To: Kristopher Byrd, Well Construction Section Manager
From: Tommy Laird, Well Construction Program Coordinator
Subject: Review of Water Right Application G-19028
Date: February 8, 2024

Application # G- 19028

TO: Water Rights Section Date 3/24/2023
 FROM: Groundwater Section Jen Woody
 Reviewer's Name
 SUBJECT: Application G- 19028 Supersedes review of 4/19/2021
 Date of Review(s)

A. GENERAL INFORMATION: Applicant's Name: James R. Means/Orenco RE, LLC County: Columbia

Figure 3. Water-Level Measurements in Nearby Wells

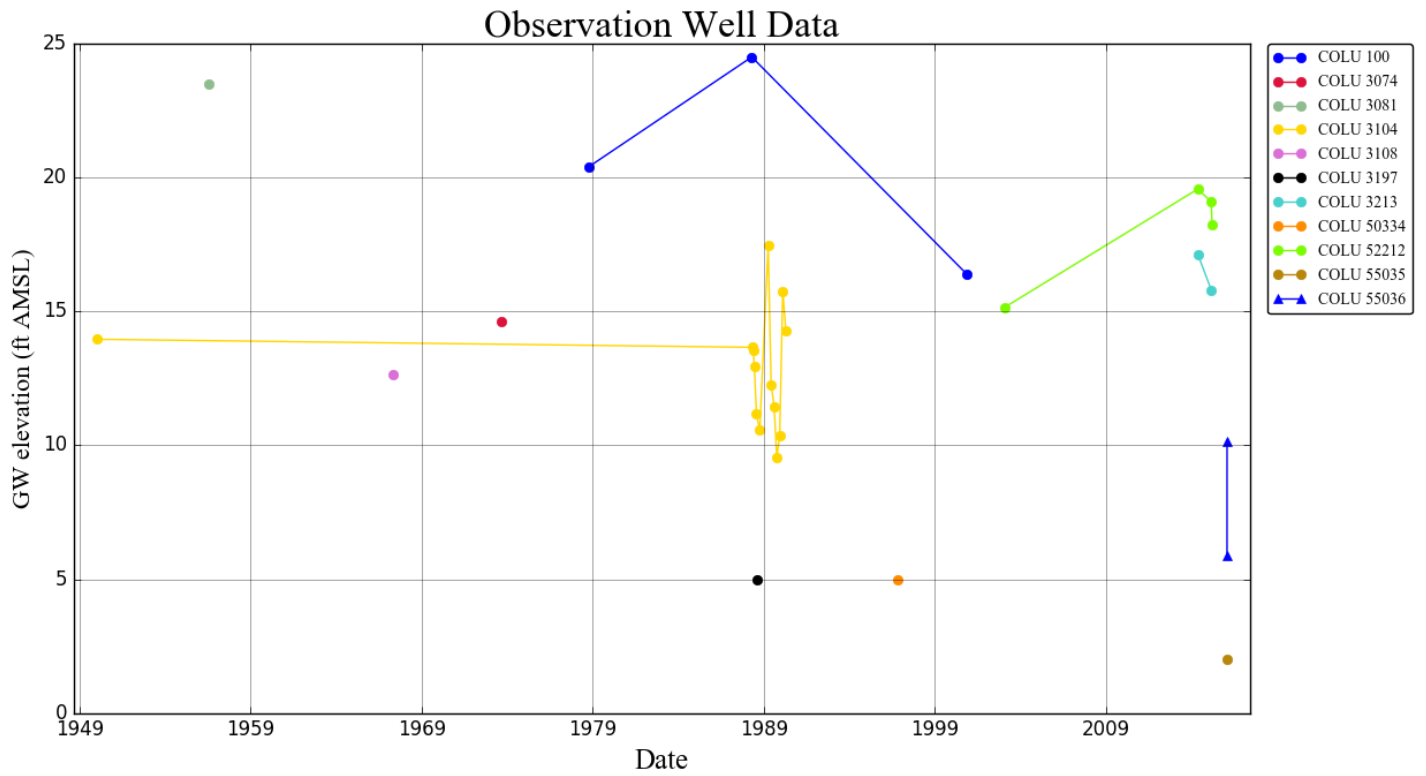
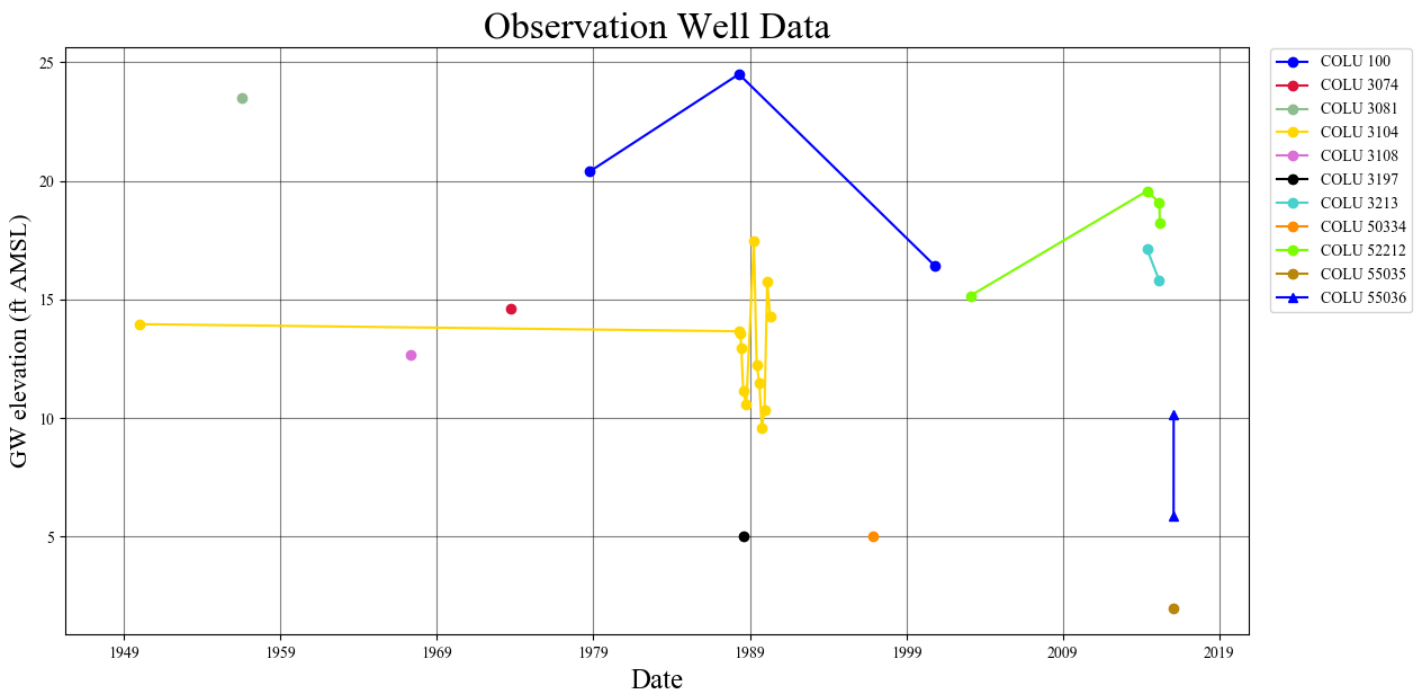
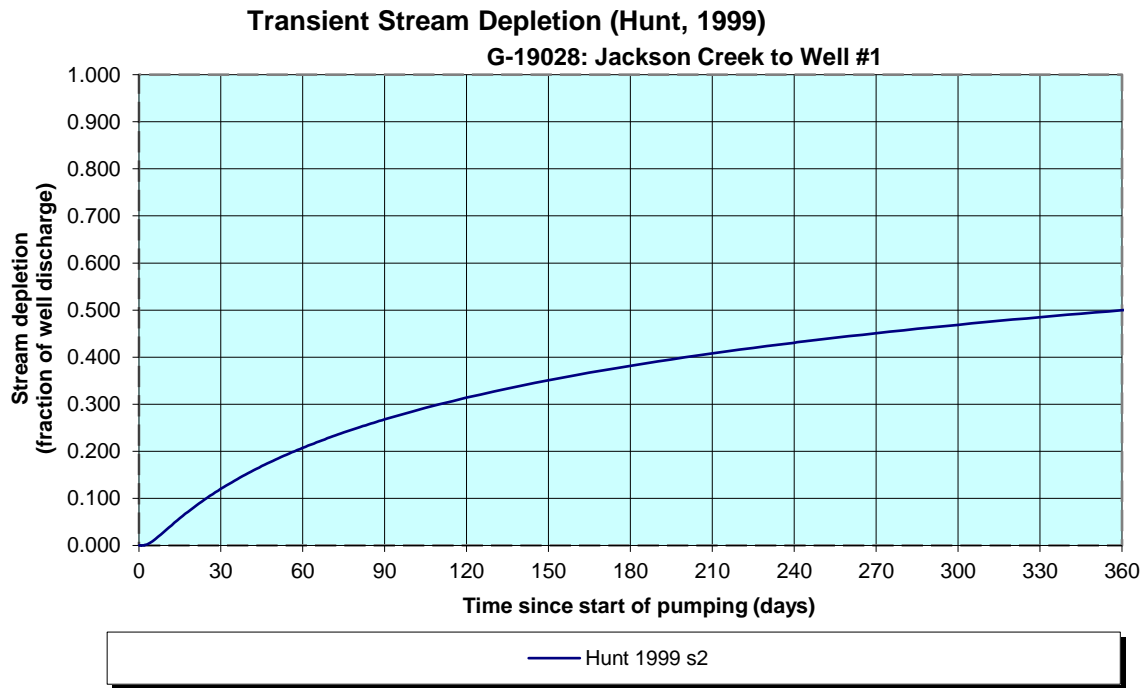
The applicant’s proposed wells are located in an area that contains coarse-grained alluvial sediments from land surface to approximately 100-200 feet. The permeable coarse-grained sediments are underlain by a sequence of fine-grained alluvial sediments. Shallow wells in the area are strongly connected to Multnomah Channel, therefore water level declines are not anticipated. There are limited nearby groundwater level time series data, but those available show stability (See Figure 3).

Figure 4. Stream Depletion Estimates

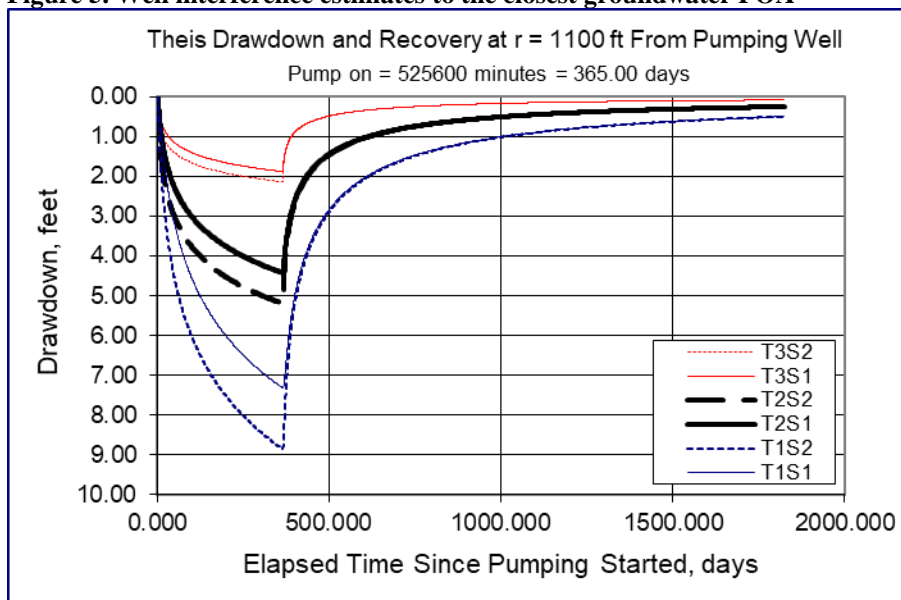
C3a. **690-09-040 (4):** Evaluation of stream impacts for each well that has been determined or assumed to be **hydraulically connected and less than 1 mile** from a surface water (SW) source. Limit evaluation to instream rights and minimum stream flows that are pertinent to that SW source, not lower SW sources to which the stream under evaluation is tributary. Compare the requested rate against the 1% of 80% *natural* flow for the pertinent Water Availability Basin (WAB). If Q is not distributed by well, use full rate for each well. Any checked box indicates the well is assumed to have the potential to cause PSI.

Well	SW #	Well < ¼ mile?	Qw > 5 cfs?	Instream Water Right ID	Instream Water Right Q (cfs)	Qw > 1% ISWR?	80% Natural Flow (cfs)	Qw > 1% of 80% Natural Flow?	Interference @ 30 days (%)	Potential for Subst. Interfer. Assumed?
1	1	<input type="checkbox"/>	<input type="checkbox"/>	n/a	n/a	<input type="checkbox"/>	No WAB	<input type="checkbox"/>	12%	<input type="checkbox"/>
2	1	<input checked="" type="checkbox"/>	<input type="checkbox"/>	n/a	n/a	<input type="checkbox"/>	No WAB	<input type="checkbox"/>	18%	<input checked="" type="checkbox"/>
1	2	<input checked="" type="checkbox"/>	<input type="checkbox"/>	n/a	n/a	<input type="checkbox"/>	No WAB	<input type="checkbox"/>	16%	<input checked="" type="checkbox"/>
2	2	<input checked="" type="checkbox"/>	<input type="checkbox"/>	n/a	n/a	<input type="checkbox"/>	No WAB	<input type="checkbox"/>	14%	<input checked="" type="checkbox"/>
